**Re: Rolling Hills Generating LLC Application for Amendment,
OPSB Case No. 12-1669-EL-BGA**

With this letter, I am enclosing the following updates and supplemental information to the information that was contained in the Amendment filed on June 1, 2012 so that the record in this matter will be complete:

- Various pages from the Amendment that have been updated (the changes have been marked in redline). The pages provided can be substituted for the pages originally filed in the Amendment and in the filing dated October 11, 2012.
- New water balance diagrams for 4 cycles of concentration and 10 cycles of concentration. These diagrams replace Figure 02-1 that was filed with the Amendment on June 1, 2012. The plant is being designed to operate between 4 cycles of concentration and 10 cycles of concentration.
- A new construction laydown drawing that replaces Figures 04-5a and 04-5b that were filed with the Amendment on June 1, 2012. The laydown area now encompasses the abandoned baseball identified in Sections 4906-13-07 (D) (4) and 4906-13-07 (D) (5) of the Application.
- Five new site grading drawings that replace Figures 04-4a and 04-4b that were filed with the Amendment on June

WATER MASS BALANCE: Units 1-5
Cooling Tower 10 Cycles of Concentration
90.0F/45%RH
(2) 2x1 with Cooling Towers
(1) 1x CTG

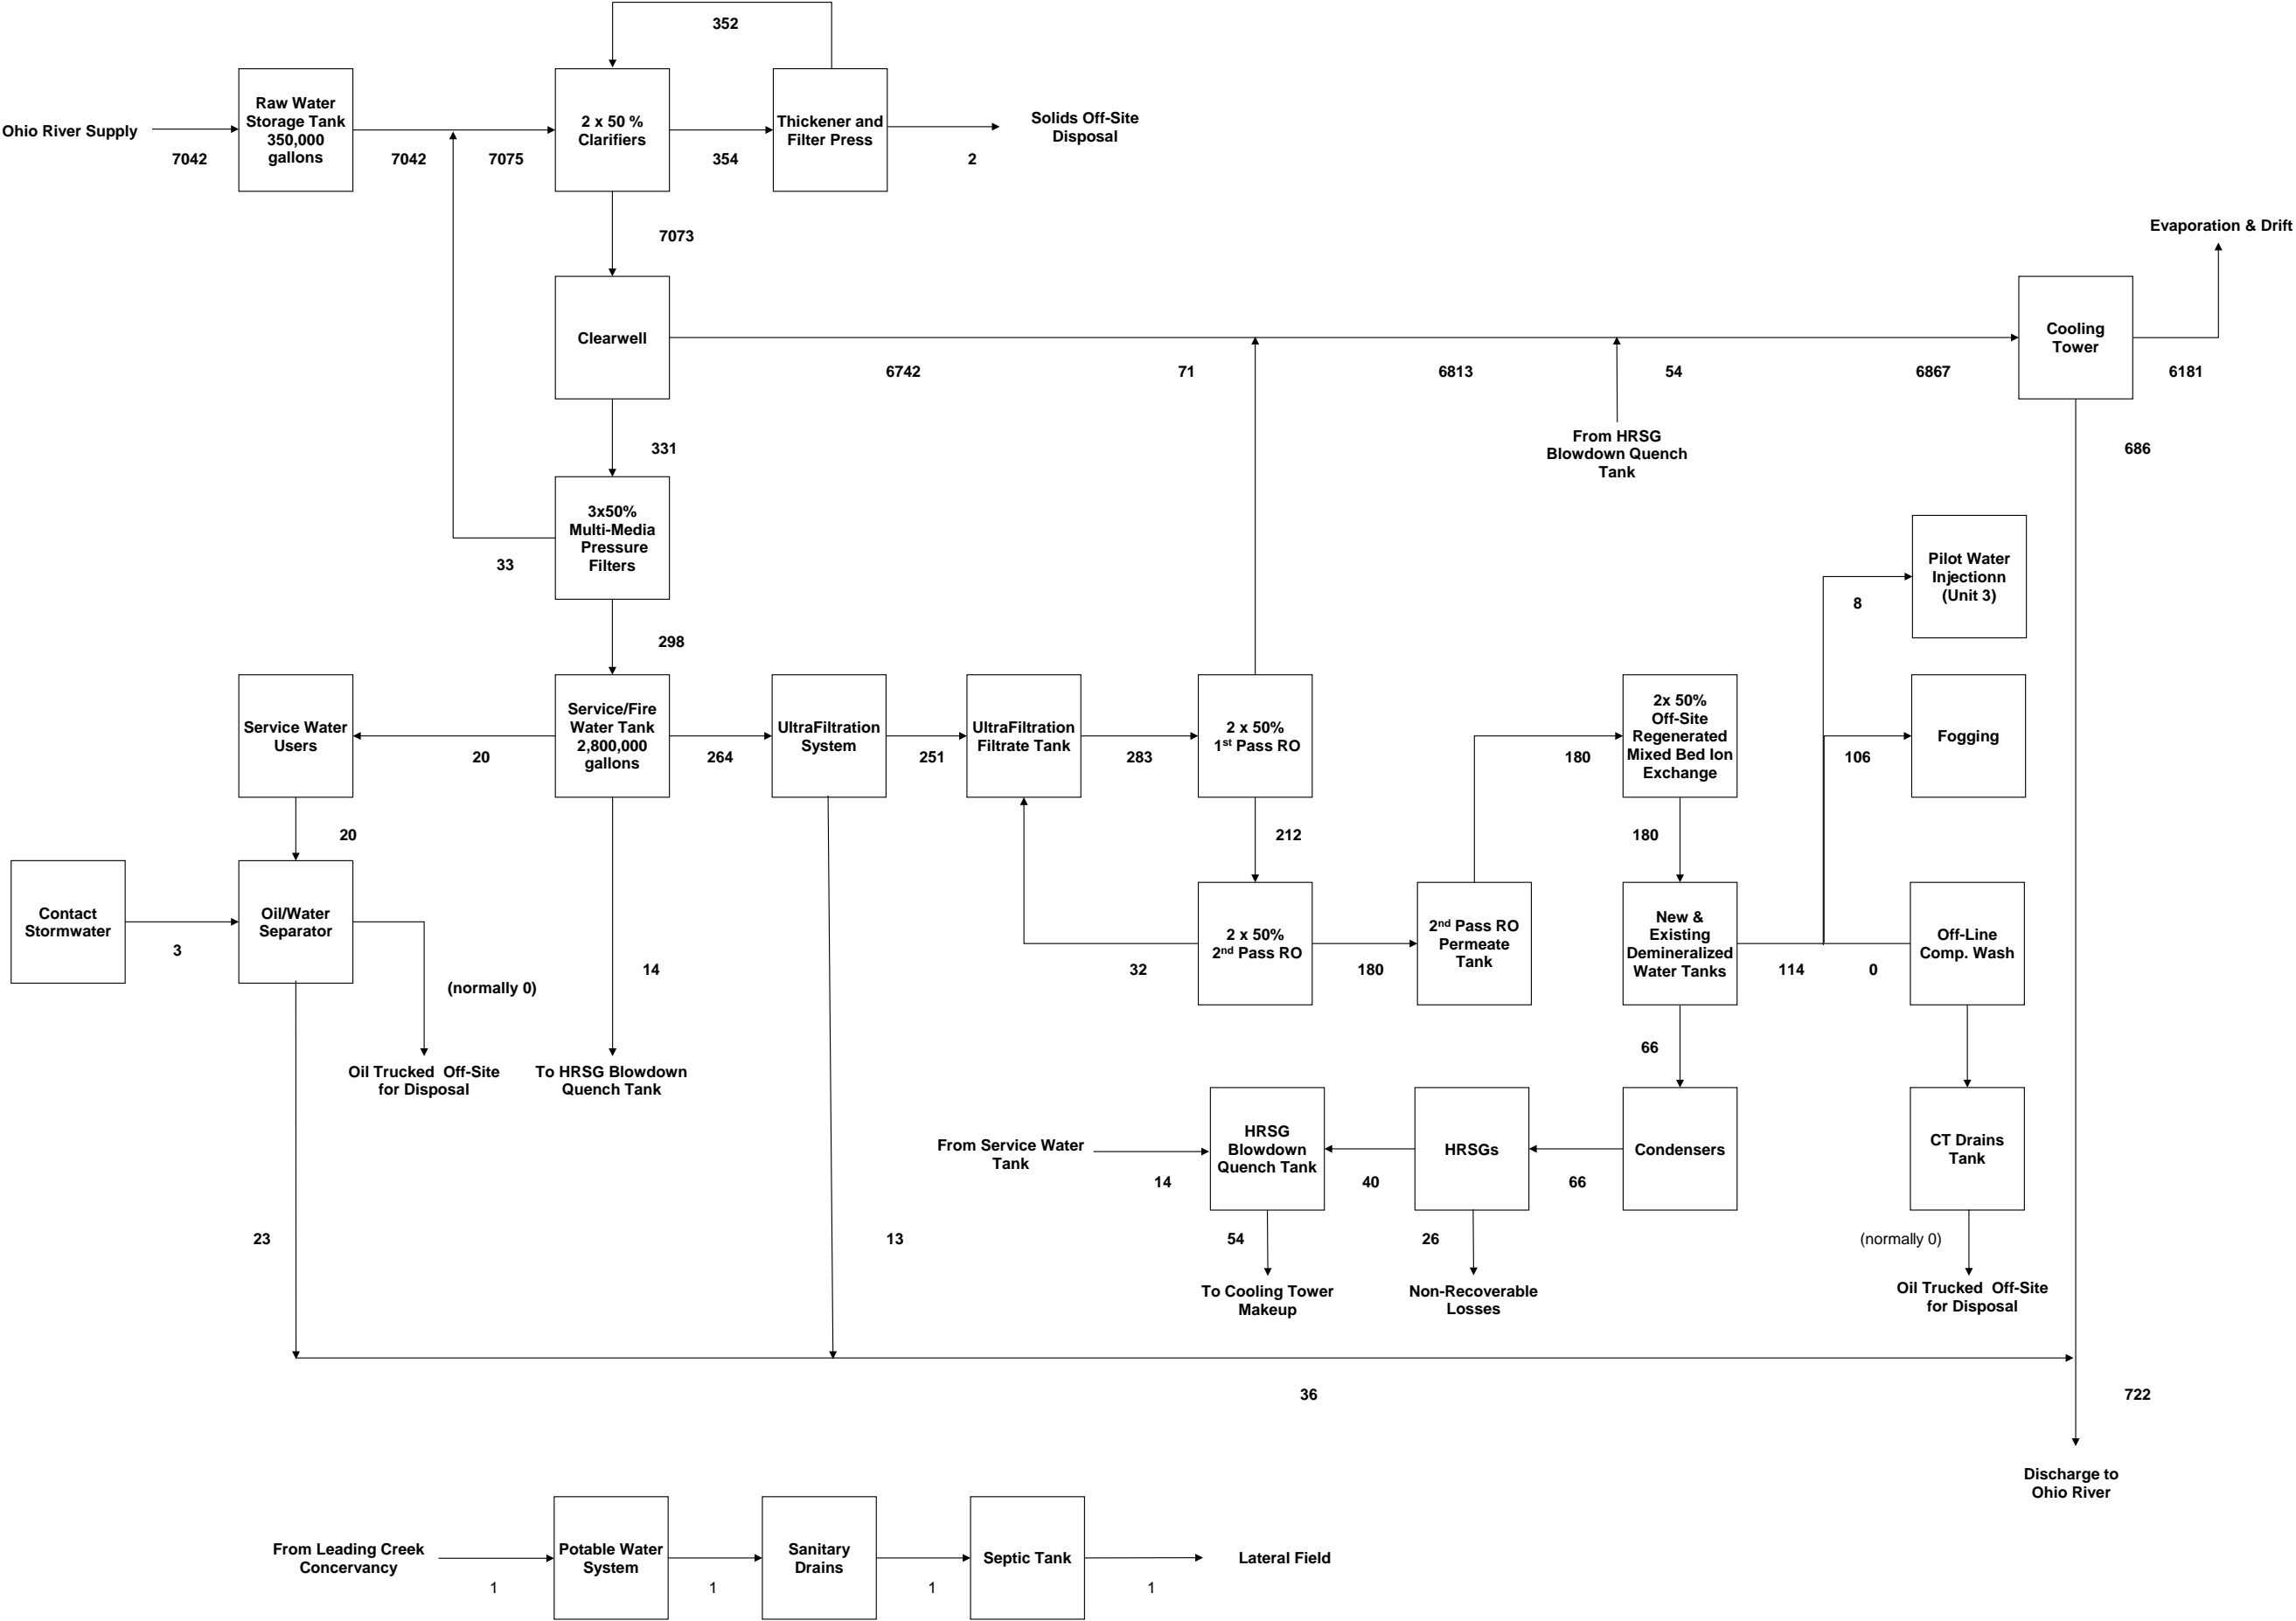
| No. | Date | By | checked | Description |
|-----|----------|-----|---------|----------------------|
| B | 11/20/12 | jkj | | Added Unit 3 Nox Inj |

WATER MASS BALANCE: Units 1-5
Cooling Tower 4 Cycles of Concentration
90.0F/45%RH
(2) 2x1 with Cooling Towers
(1) 1x CTG

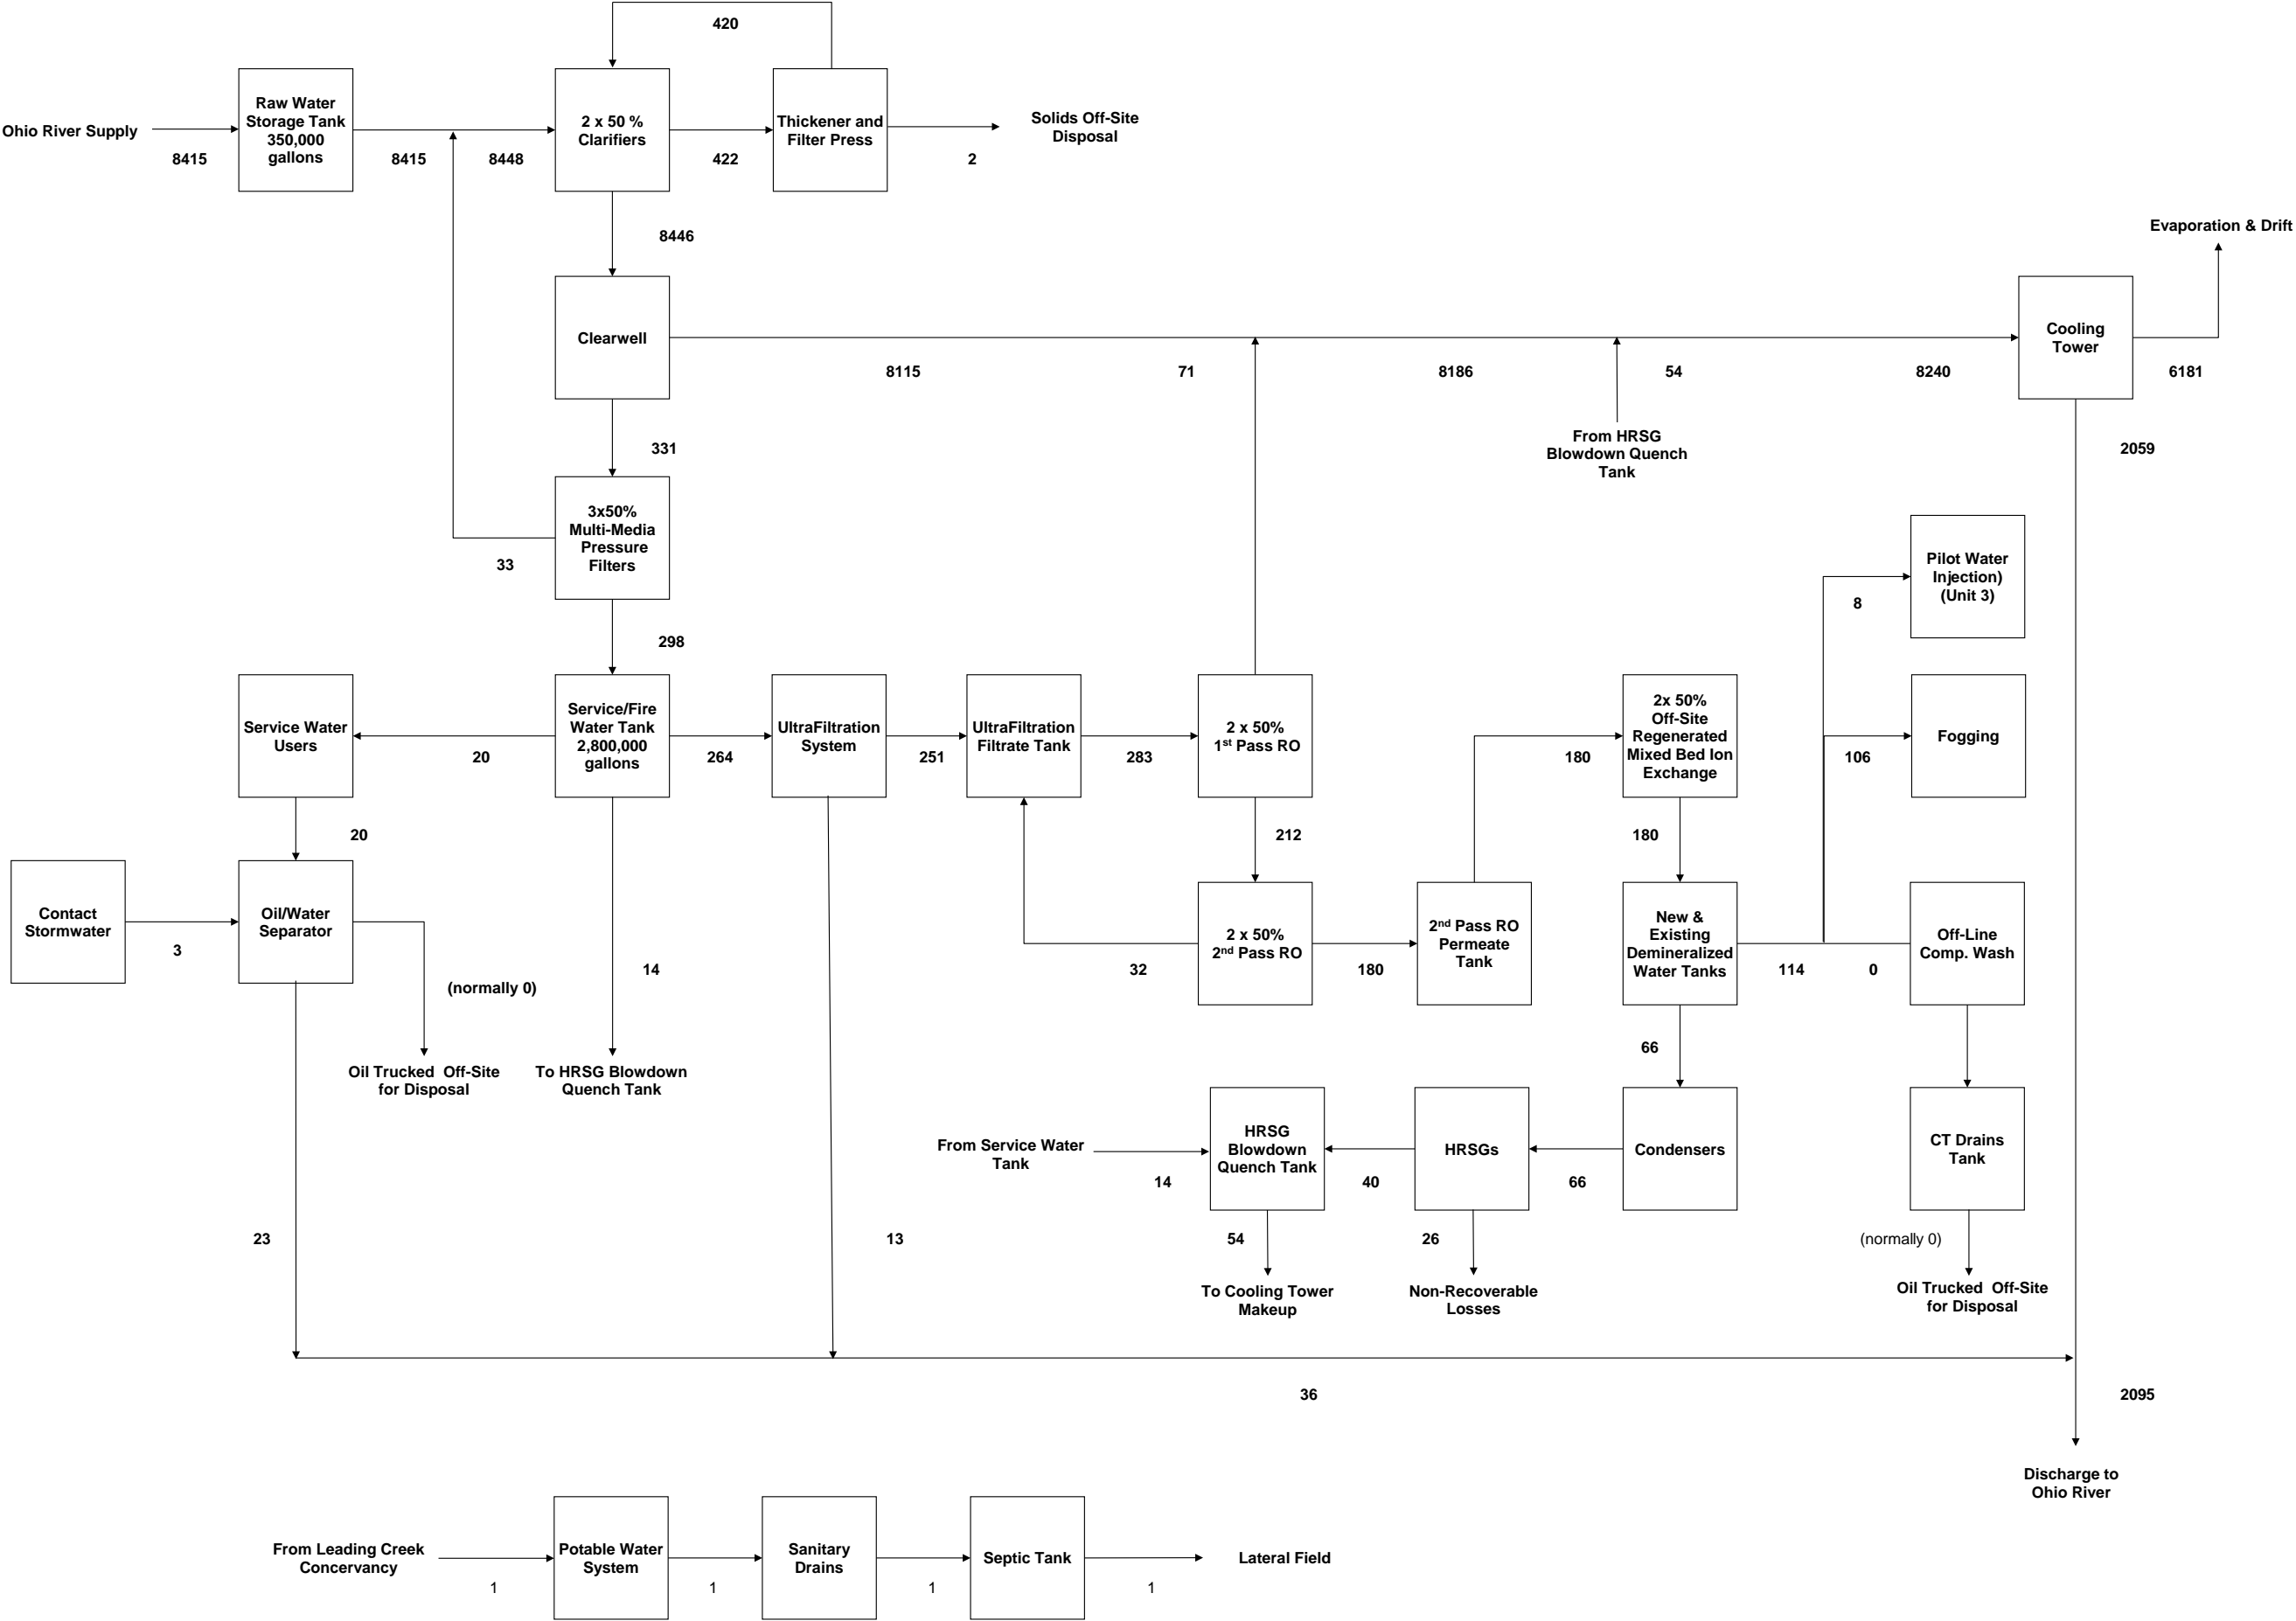
| No. | Date | By | checked | Description |
|-----|----------|-----|---------|----------------------|
| B | 11/20/12 | jkj | | Added Unit 3 Nox Inj |
